Technical Memorandum

To:	Kathy Arnold	From:	Amy L. Hudson, REM
Company:	Rosemont Copper Company	Date:	November 23, 2010
Re:	Rosemont Infiltration, Seepage, Fate and Transport Response to Comments	Doc #:	268/10-320884-5.3
CC:	David Krizek. P.E.; Mark Williamson (Tetra Tech)

ATTACHMENT 1
TECHNICAL REVIEW OF INFILTRATION, SEEPAGE,
FATE AND TRANSPORT MODELING REPORT, TETRA
TECH, 2010, PREPARED FOR ROSEMONT COPPER
COMPANY (SRK, 2010)

Illustration 1.0 Modified Particle Size Distribution

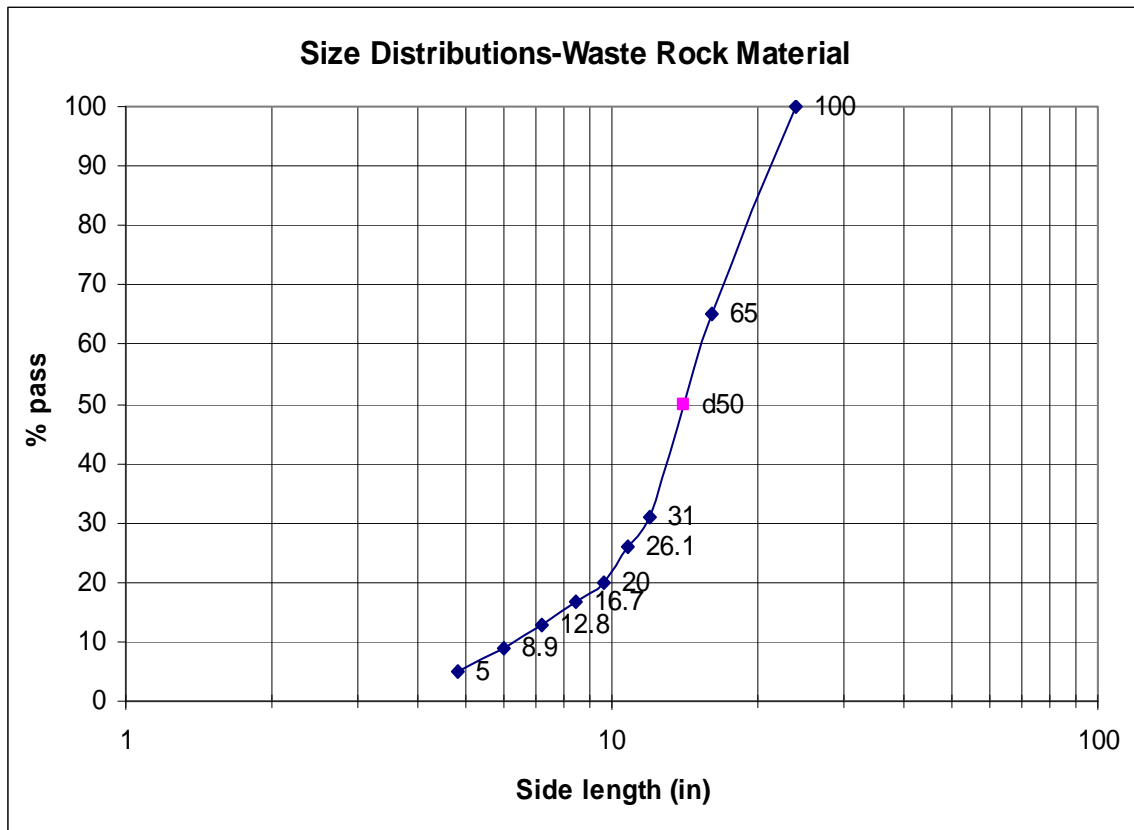
1. *Consider the impacts of leaching the oxide material and its impact on the hydraulic conductivity and the use of a run of mine material property to model the heap.*

- 2. The draindown rate seems to underestimate the time that will be required to reach a rate of ten gallons per minute and will require management during and after reclamation.*

Based on Appendix F of the May 2009 design report - Design Criteria (Tetra Tech, 2009b), run-of-mine (ROM) ore will be placed on the pad. Estimated ROM particle size distributions were determined for the Rosemont deposit by Call & Nicholas, Inc. (CNI, 2008). CNI calculated four (4) fragment size-distributions for the ore and waste rock materials in the Rosemont Open Pit. The fragment size-distributions included sulfide ore, oxide ore, and two (2) waste rock types. Subsequent analysis performed in conjunction with designing the flow-through drain structures (Technical Memorandum titled *Rosemont Flow-Through Drain Design* (Tetra Tech, 2010c) dated April 5, 2010) determined that the ROM waste rock is anticipated to have a D50 of about 14" with 80% of the rock materials under 24" in diameter (see Illustration 1.0 below). The oxide ore is anticipated to have a similar distribution.

The oxide ore material will generally be stacked in 30 foot lifts following two (2) 20-foot starter lifts on the down-gradient side of the Phase 1 Pad. A haul road will divide the Phase 1 Pad from the Phase 2 Pad.

As described in the response above, the material being placed on the heap leach pad will be ROM sized material. Based on the gradation presented in Illustration 1, the ROM material includes few fines and will generally have a high saturated hydraulic conductivity. The type of material anticipated to be placed in the heap is also not expected to breakdown and generate a significant amount of fines due to the chemical leaching. Because of the lack of fines and high saturated hydraulic conductivity, the heap leach will drain freely after leaching operations cease. A review of conditions at other heap leach pads currently in closure or post-closure in Arizona and Nevada support the conclusion of the draindown rate reaching approximately ten (10 gallons per minute within a three (3) year period.

Figure 1 Example of soil water characteristic curve (SWCC)

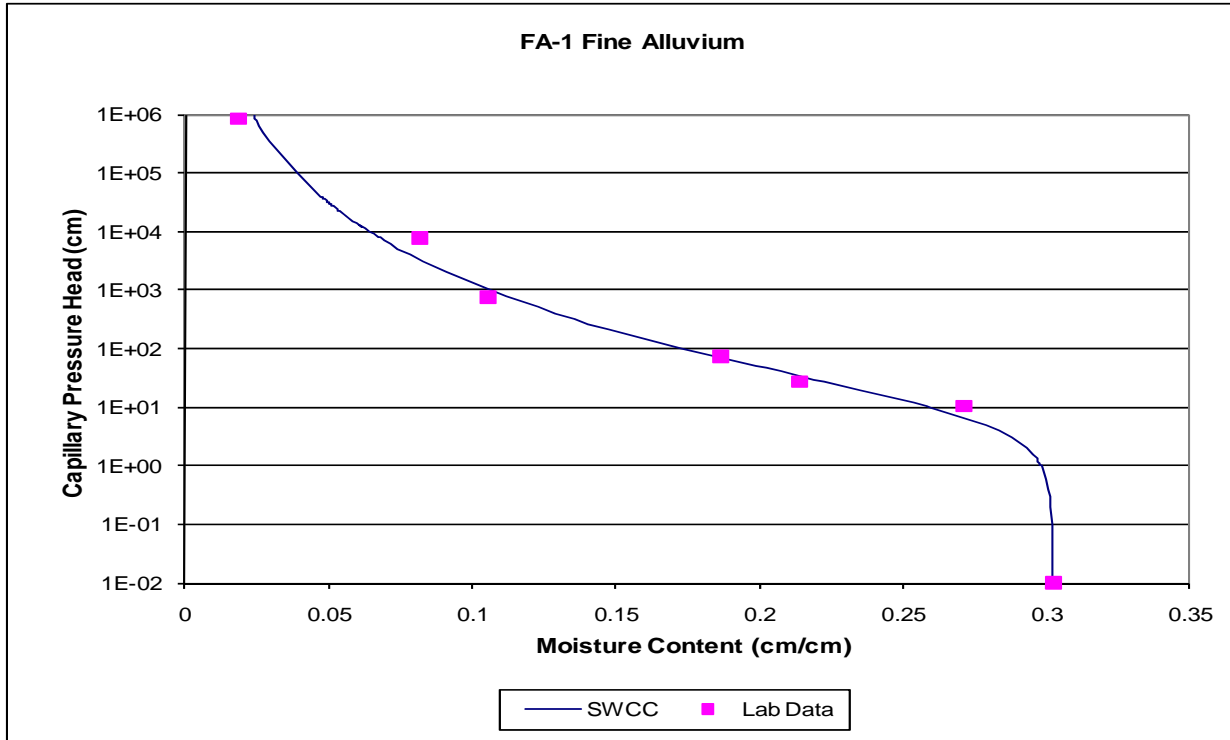
1. *Provide illustrations of the hydraulic conductivity and moisture content functions used in the modeling.*

Section 5.3 of the report provides an explanation of unsaturated flow theory. Illustration 5.5 shows a generic soil water characteristic curve (SWCC) for two soils, however, an illustration of hydraulic conductivity as a function of capillary function or moisture content is not presented or discussed. Section 5.5.5 presents saturated hydraulic conductivity values for three waste rock materials, alluvium, and bedrock without providing either a range of values, or a source for the saturated hydraulic conductivity data.

Illustrations of the hydraulic conductivity and water content functions were added to the descriptions of input parameters provided in Sections 5.5.5.1 through 5.5.5.5 of the updated report (Tetra Tech, 2010b).
